Royal Canal Greenway - Maynooth to Dublin County Boundary

On behalf of Dublin Cycling Campaign (www.dublincycling.ie) and Cyclist.ie – the Irish Cycling Advocacy Network (www.cyclist.ie), the member for Ireland of the European Cyclists' Federation (www.ecf.com), I would like to express strong support for the proposed Royal Canal Greenway from Maynooth to Dublin County Boundary.

Detail showing inadequate provision for cargo bikes and bicycles with trailers

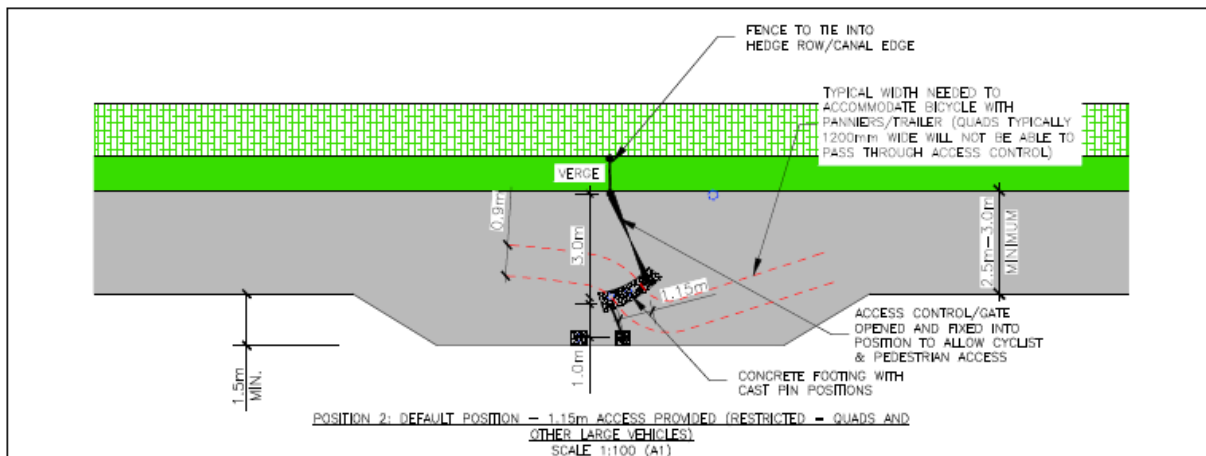
- We note the proposal (as shown in Drawing AC-001 and copied below) to use restricted access gates at a number of locations along the route. These access arrangements only allows one user to pass at the one time and will result in users of cargo bikes / tricycles and bikes with trailers having to come to a complete stop. Adequately spaced bollards are best practice solutions in cycling-friendly countries.
